SP2023-020; Site Plan for 5811 FM 3097

PROJECT NUMBER: SP2023-020
PROJECT NAME: Site Plan for 5811 Horizon Rd
SITE ADDRESS/LOCATIONS:

CASE CAPTION: Discuss and consider a request by Veronica O'Neal on behalf of Ashwani Agarwal and Azul Kumar for the approval of a Site Plan for a Daycare Facility on a 2.308-acre tract of land identified as Lot 21 of the Rainbow Acres Addition, City of Rockwall, Rockwall County, Texas, zoned Commercial (C) District, addressed as 5811 Horizon Road [FM-3097], and take any action necessary.

TO: Planning and Zoning Commission
FROM: Henry Lee, *Senior Planner*
DATE: July 11, 2023
SUBJECT: SP2023-020; *Site Plan for 5811 Horizon Road (FM-3097)*

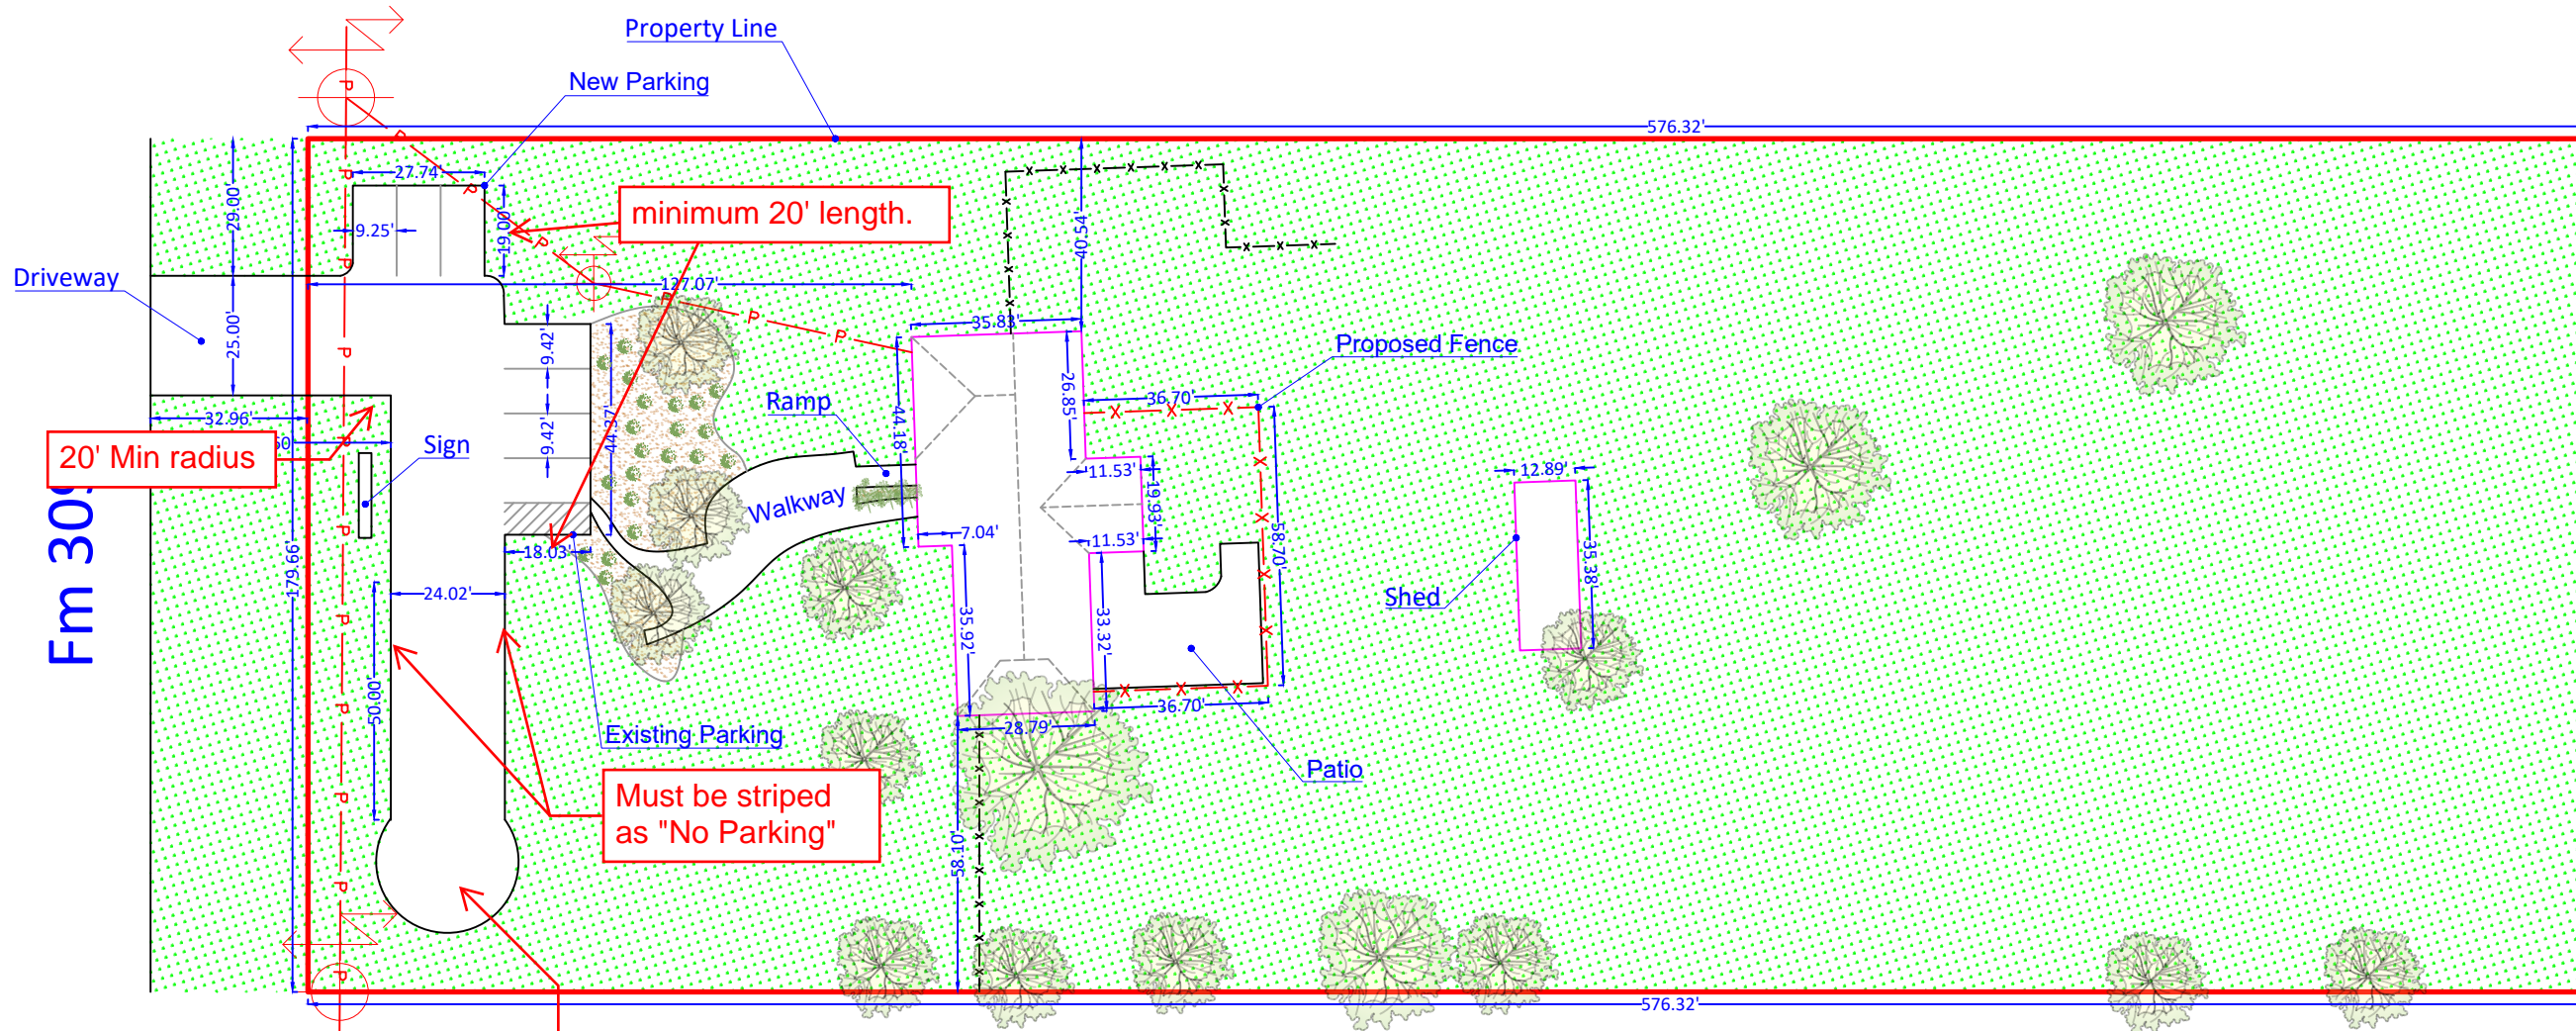
- General Items:**
- Must meet City Standards of Design and Construction
 - 4% Engineering Inspection Fees
 - Impact Fees for expansion
 - Minimum easement width is 20' for new easements. No structures allowed in easements.

- Retaining walls 3' and over must be engineered.
 - All retaining walls must be rock or stone face. No smooth concrete walls.
 - Must plat the property.

- Fire lane to be in a platted easement.
 - TxDOT Traffic Impact Analysis is required. review fees apply.
- Water and Wastewater Items:**
- Show existing/proposed utility lines (Water, Sewer, etc.)

- Detention outfall must be at sheet flow conditions prior to property line
- Landscaping:**
- No trees to be with 10' of any public water, sewer or storm line that is 10" in diameter or larger.

DayCare/Preschool
Site Plan

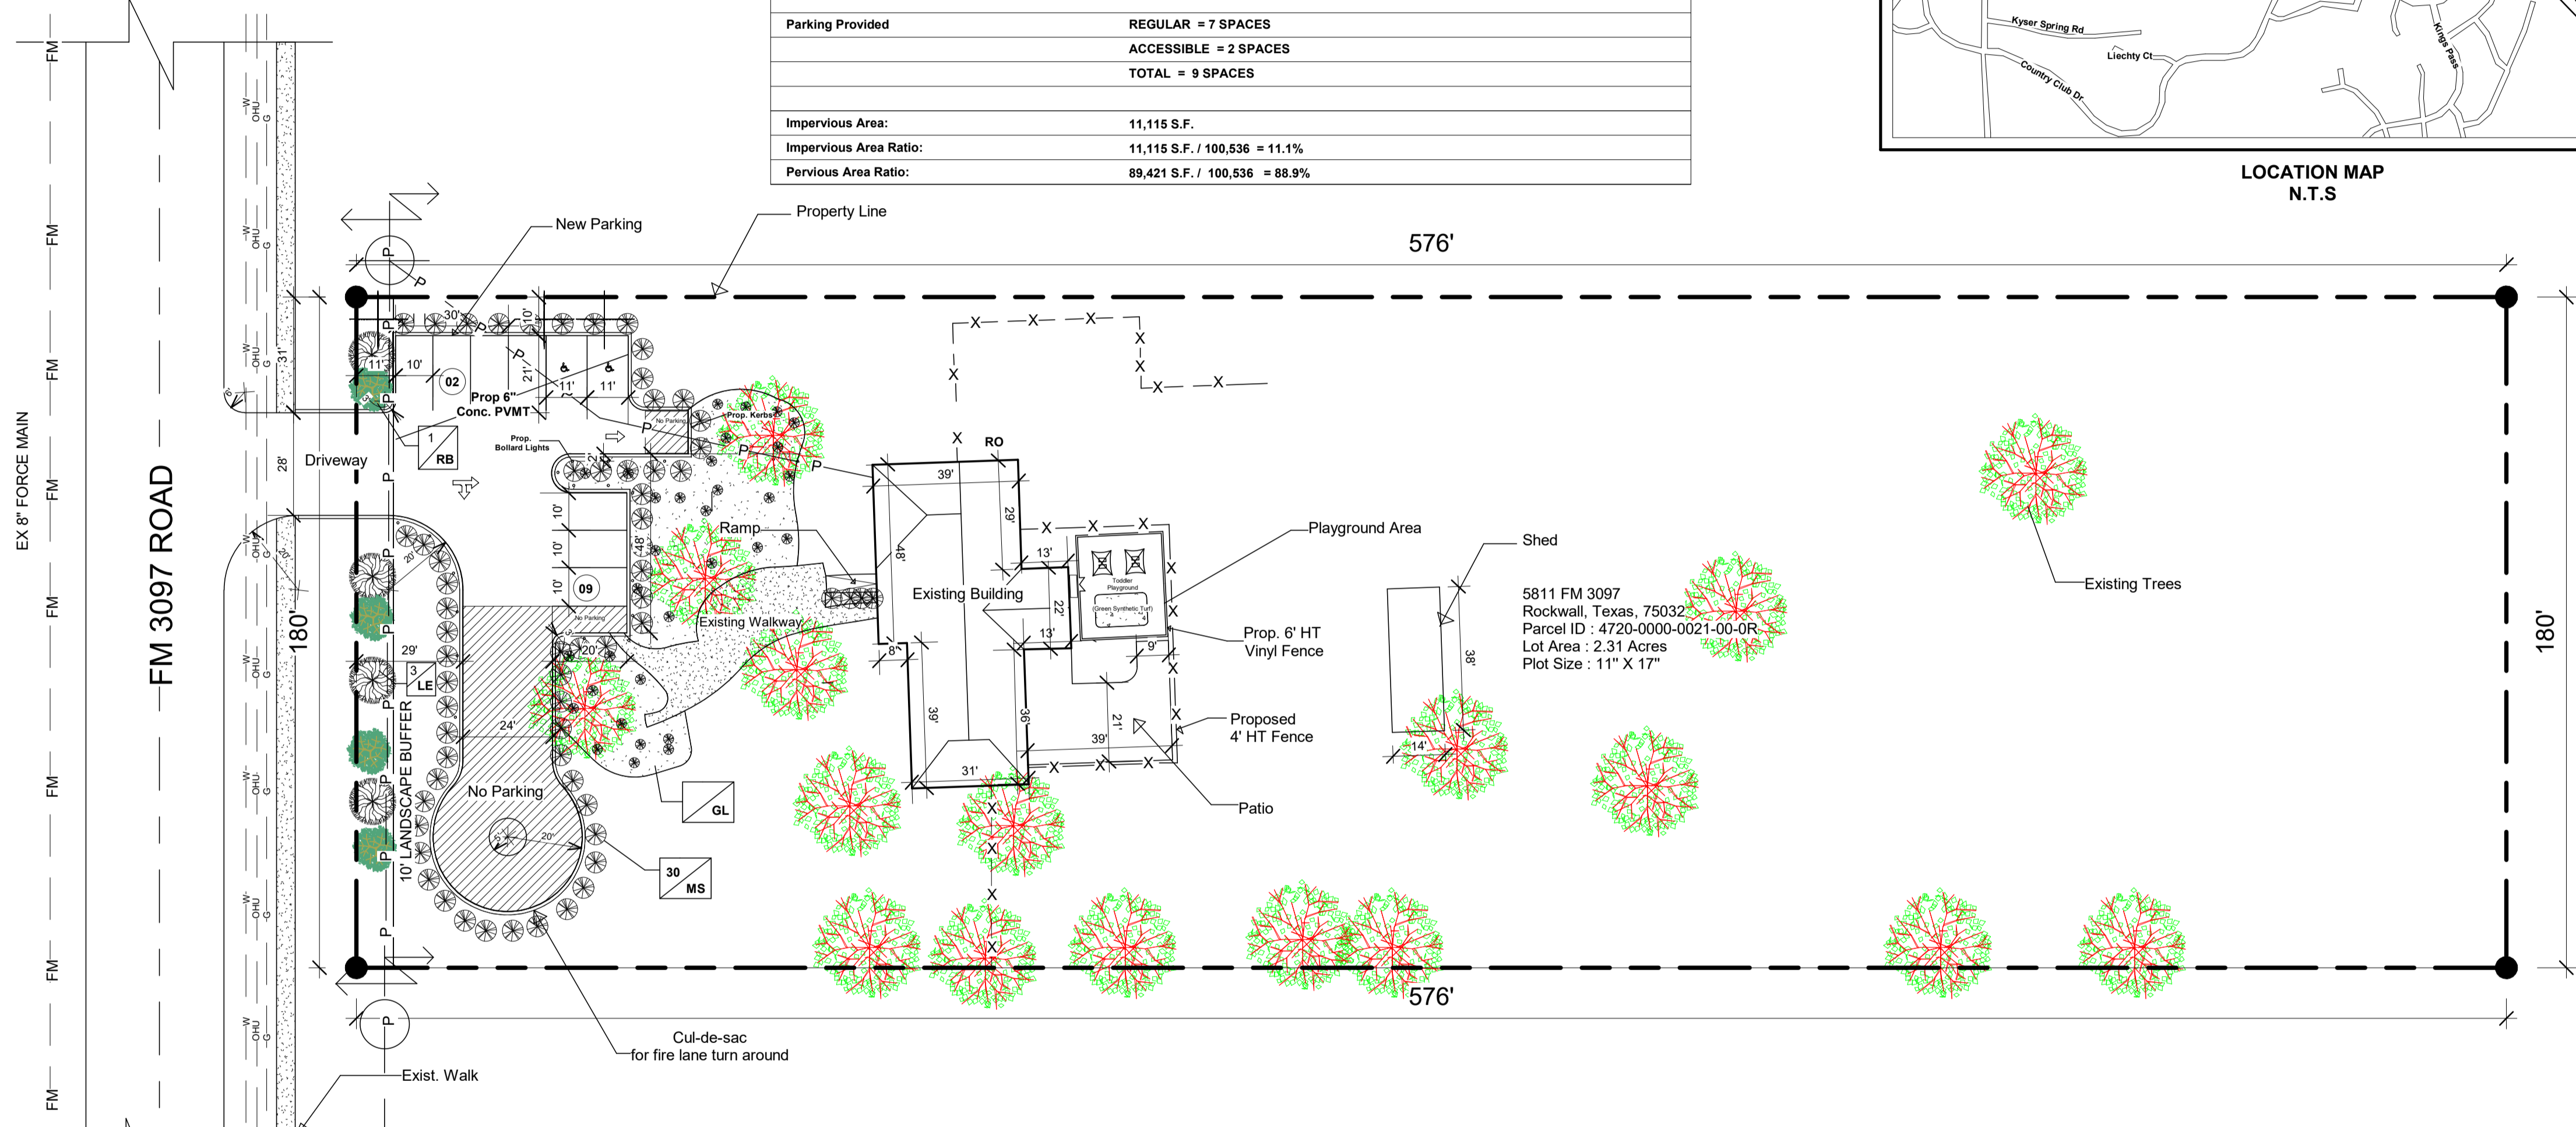
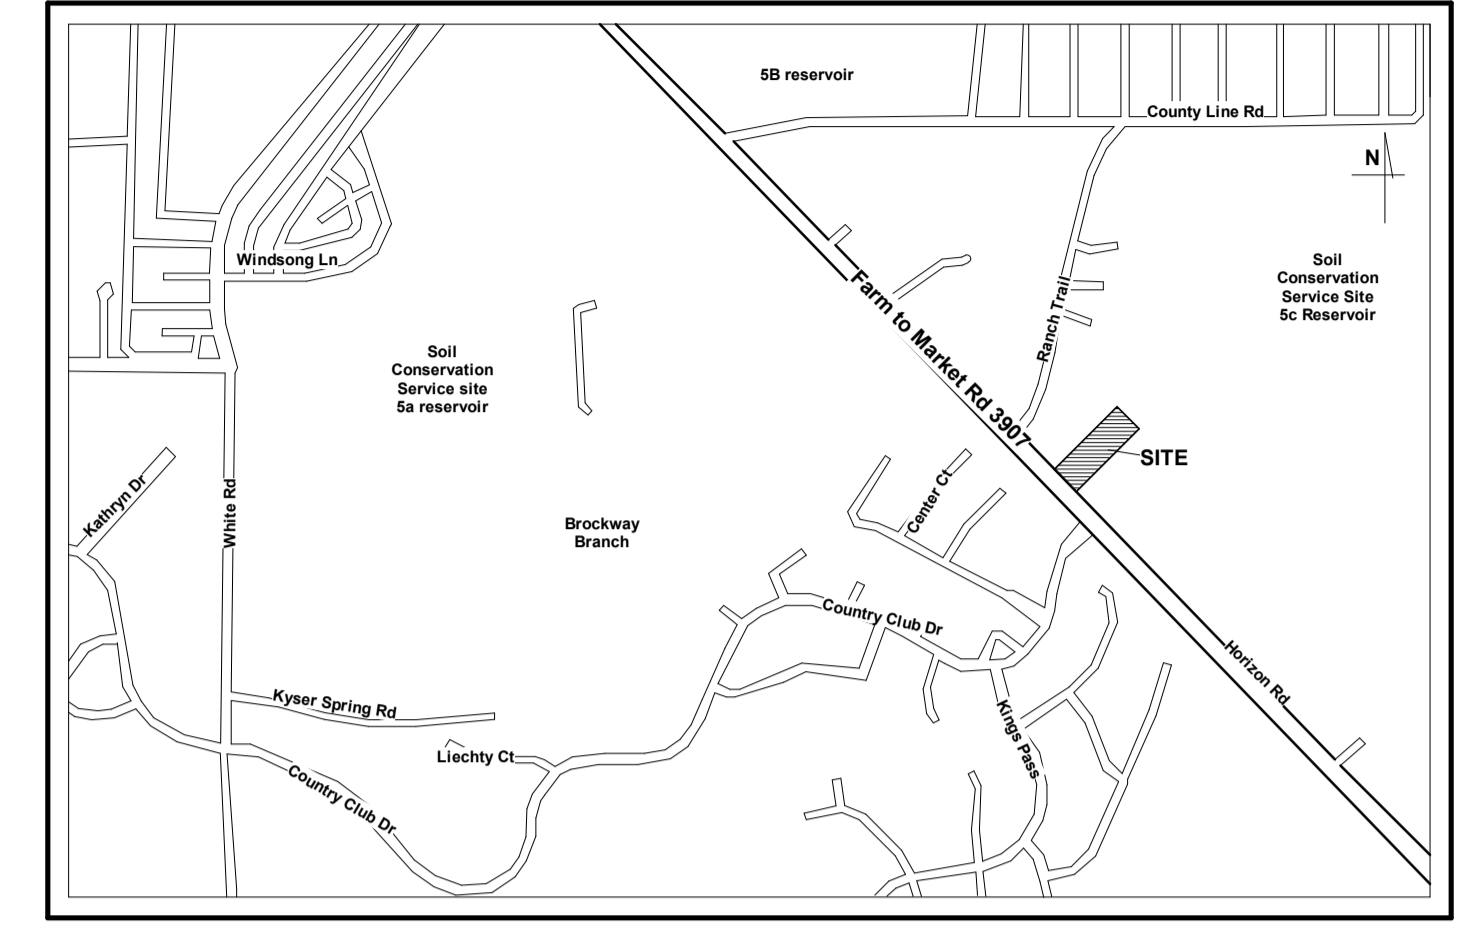
I think there may have been some confusion. You just need a 10' Landscape Buffer along the front of the property (adjacent to Horizon [FM 3097]) within that landscape buffer, you still need 4 canopy and 4 accent trees. Please specify the name of each landscape item. Also, according to our aerials (within the last 2 months) the north side of the property only has a few trees, are you planning on planting the rest of them? If so, that is not required. The only required trees are the 4 canopy (4 inch Caliper) and 4 accent in the front. In addition, you need shrubs (5 gallon evergreen shrubs placed every 3 feet) along the front of the parking spaces.
